# memorandum

subject Proposed 8316 Avalon Drive Residence Critical Areas Determination (CAO17-002) –  
Environmental Review

**Figure 1. Markup Showing Approximate Locations of Observed Wet Areas**

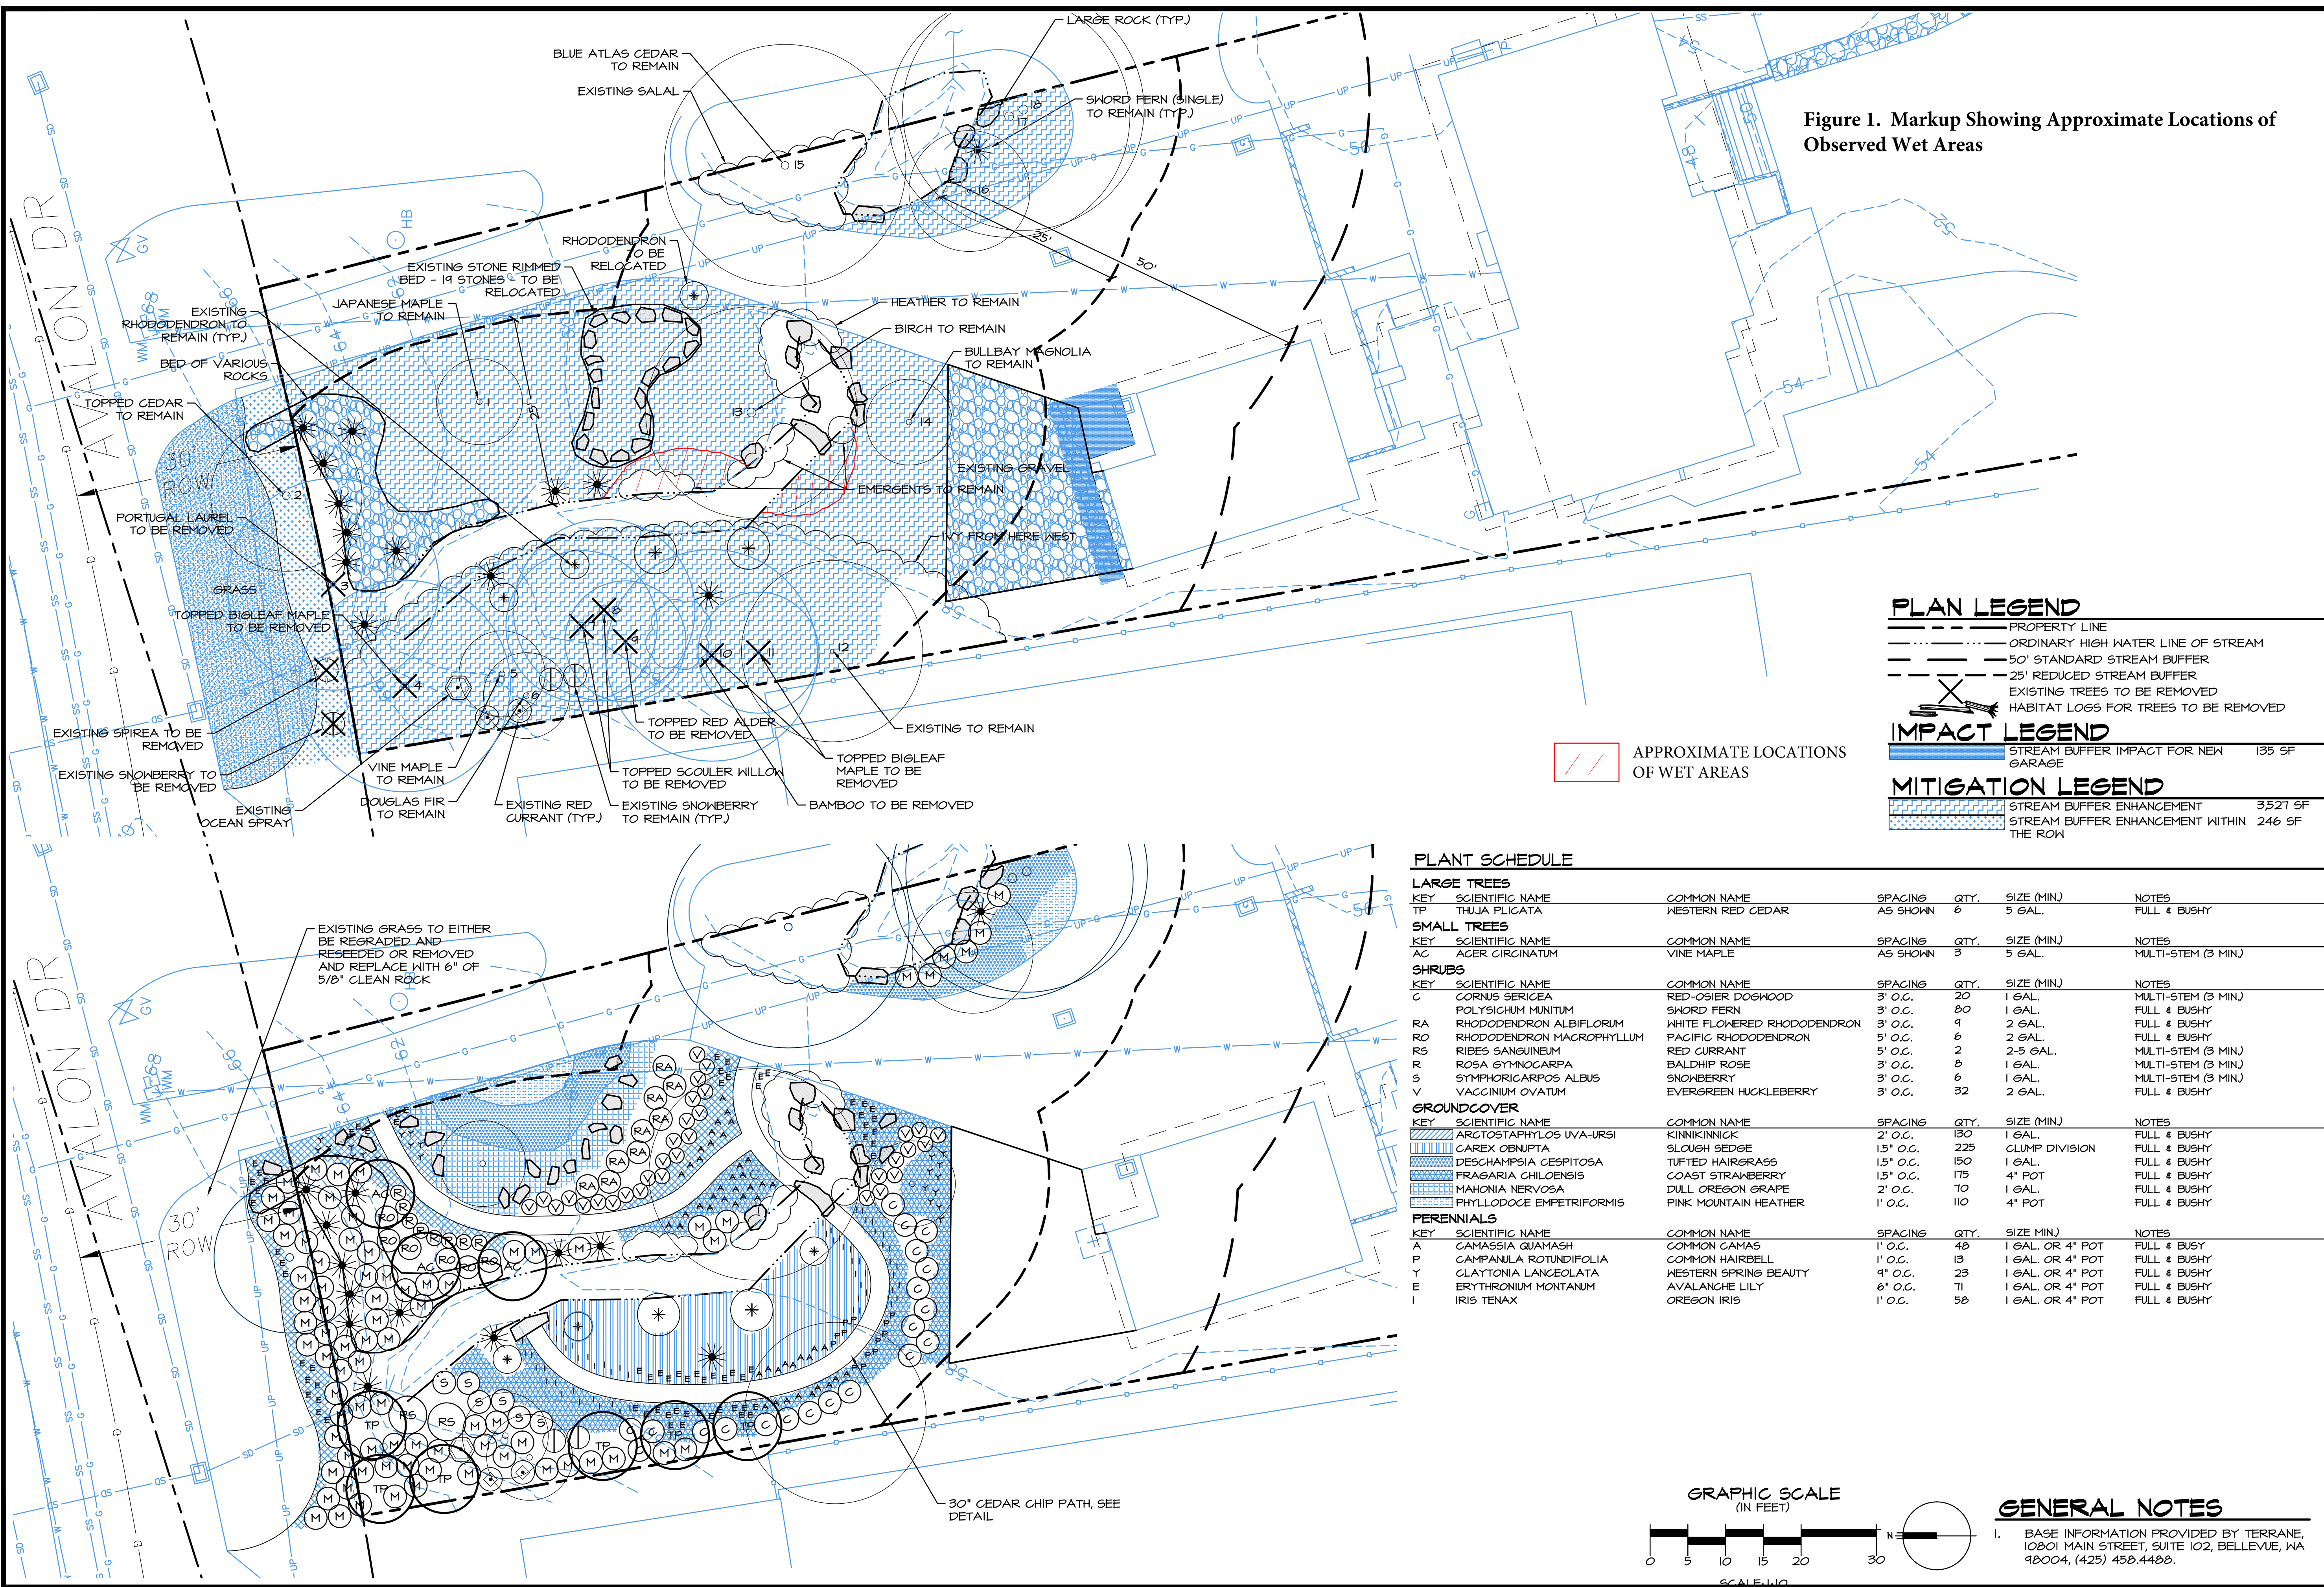
During our site visit, most of the project site consisted of upland plant communities and bright, drier soil that did not suggest wetland conditions. However, in two relatively small areas adjacent to the on-site stream, dark, saturated soils containing redoximorphic features were observed. One of these areas was east of the stream between the stone-rimmed garden area and where the stream turns to the east. The other area was south of this turn, to the north of the gravel parking area. See Figure 1 (marked-up sheet from the Buffer Mitigation Plan) for approximate locations of wet areas. The dominant vegetation in these areas was field horsetail (*Equisetum arvense*). The Critical Areas Study did not identify any wetlands on site and it does not appear that Altmann Oliver Associates established any formal data plots to document existing conditions. Based on our observations, we recommend that the applicant's consultant provide additional information to document existing conditions in these areas. Depending on the findings, it may be appropriate to include these areas within the ordinary high water mark (OHWM) of the stream, or they may be identified as separate wetlands.

- Update the planting plan to include Sections 3.0 through 6.0 from the CAS.
  - We recommend increasing the spacing of the western red cedars (*Thuja plicata*) to at least 15 feet apart to give them room to grow.

- On the planting plan, sword fern (*Polystichum munitum*) does not have a corresponding letter in the plant schedule. Confirm if “M” corresponds to sword fern and revise the plant schedule accordingly.

- If wetland areas are identified on the site (or the OHWM is expanded to include wetter areas along the stream corridor), soil and hydrology conditions should be taken into account for plants

selected for these areas. For the areas noted on Figure 1, we recommend the following plant changes to species more appropriate for wet conditions:

- Substitute sword fern with Labrador tea (*Ledum groenlandicum*)
  - Substitute coast strawberry (*Fragaria chiloensis*) with bunchberry (*Cornus canadensis*)
  - Substitute common camas (*Camassia quamash*) with western columbine (*Aquilegia formosa*)
- The Construction Specifications should specify that pesticides are not permitted within the enhancement area.
